BOARD ACTION REPORT – APPEALABLE ITEM

Project Name: Tin Roof Expansion

Request: Certificate of Appropriateness & Class I Site Plan

HISTORIC PRESERVATION BOARD STAFF REPORT

NEW APPELAL PLANT MOUNTED ON ROLL DOWN GATE

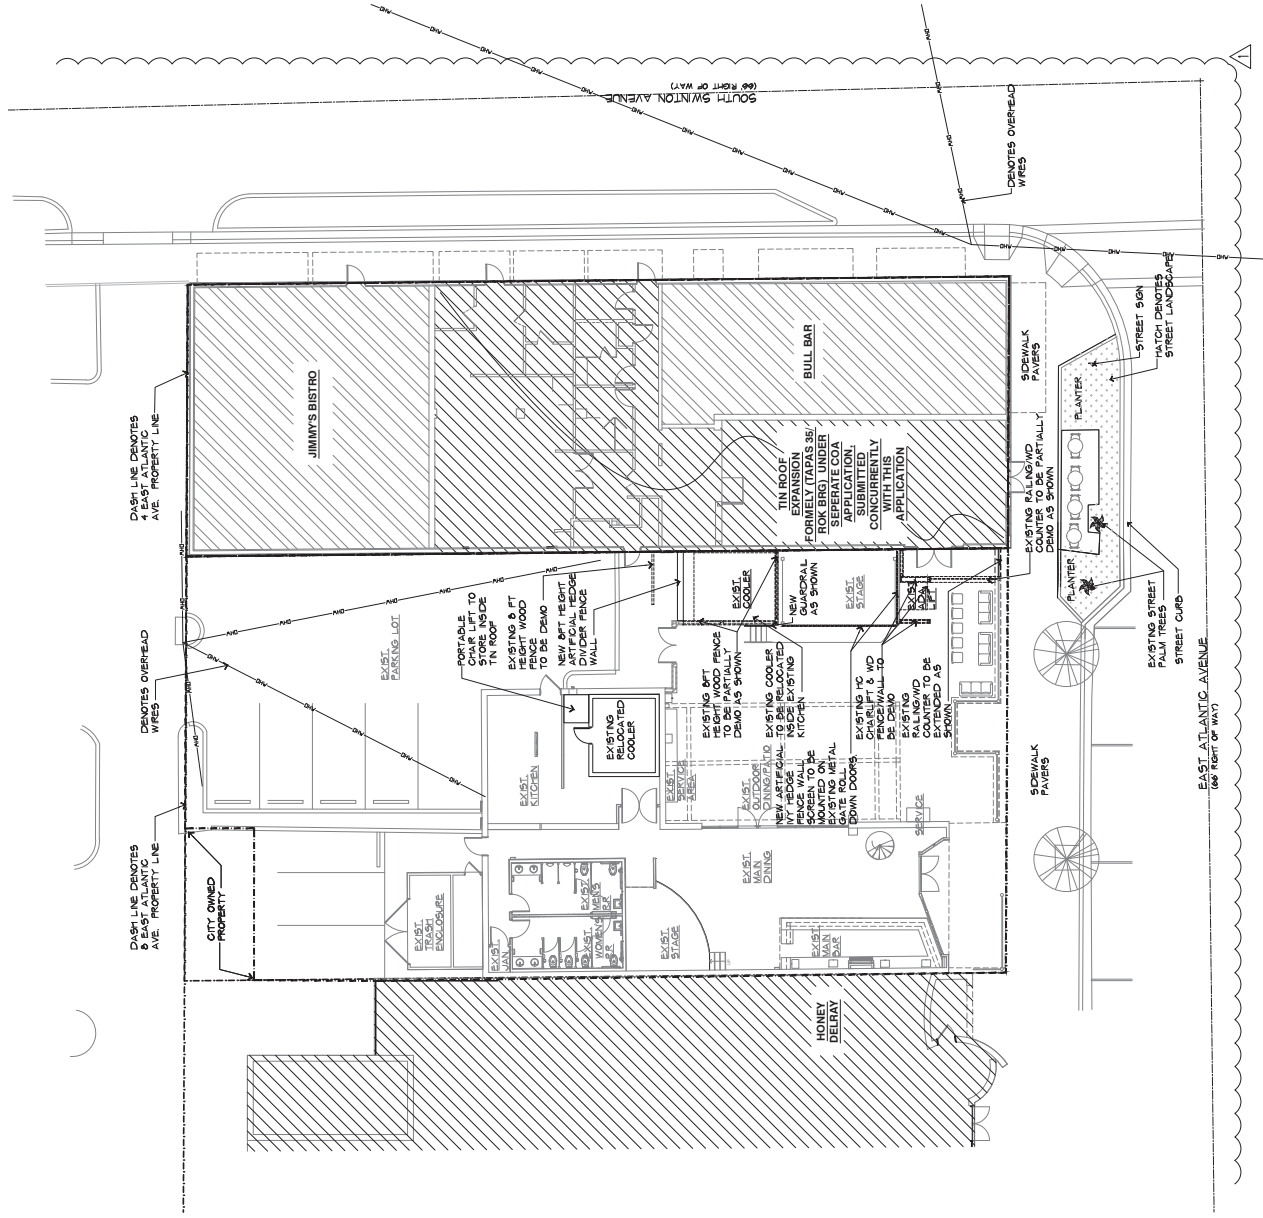
There is concern with the metal roll down gates and their associated metal storage box. First, they have an industrial appearance which is not compatible with the historic district and architectural style of the buildings on the property. The applicant is proposing to screen the gates with faux, plastic ivy hedge material to soften the look of the gates; however, there is concern with the use of synthetic materials within the historic district as they are discouraged when visible from a public right-of-way. It is also noted that such material does not hold up well to the elements and eventually loses its green appearance. Typically, the gates are rolled up at night during performances and are rolled down during the day, storing into a metal storage box, which is mounted at the top of the cabana roof. Neither the gate storage boxes nor the gates are adequately screened.

The applicant has indicated that they are currently considering other options for screening the roll down gates that would be more visually appropriate and that they would like to work with the city to decide on a compatible material for the gates prior to the issuance of building permit. An acceptable solution to screen

The use of artificial hedges and ivy is not considered appropriate to the historic character of the building as it is not a feature or finish that was used during the time period to which the property was constructed. The use of actual foliage and greenery, or some other type of authentic material used to screen yet enhance the craftsmanship of the façade would be more suitable.

the storage boxes would be to clad the boxes with a wood valence or fascia. An added condition of approval is that the roll down gates and metal gate storage boxes be screened with authentic materials that are appropriate to the historic district.

- 1. That the roll down gates and metal gate storage boxes be screened with authentic materials that are appropriate to the historic district and are visually appealing from the public right-of-way; and,

PART PLAN, EXIST' & PROPOSED EAST ELEVATIONS

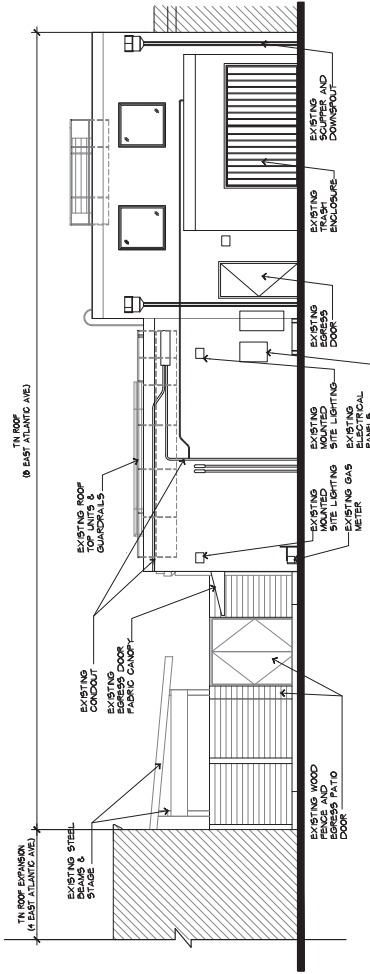
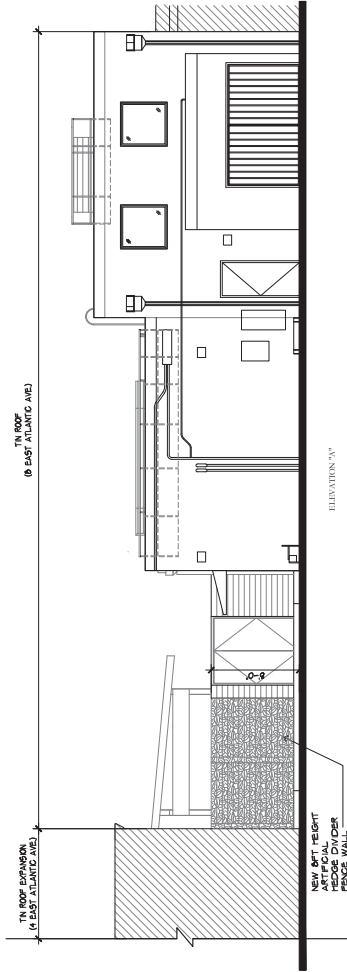
Additionally, the proposal includes a faux ivy hedge on the fence along the south side of the outdoor patio, which is also visible from the right-of-way. This area could accommodate an authentic living wall with real plant material or a hedge. This item is added as a condition of approval.

Regarding Standard #5, the artificial hedge proposed for screening the roll down gates and divider fence wall uses inauthentic materials for the historic district.

With regards to the proposed faux ivy hedge, this material is not considered to be durable and will likely fade quickly giving an unattractive appearance. As discussed in a previous area of the staff report, a condition of approval has been added to allow for a more visually compatible material for the roll down gates and the fence on the south side of the patio.

- 2. That the real plant material be utilized on the fence along the south side of the outdoor patio.
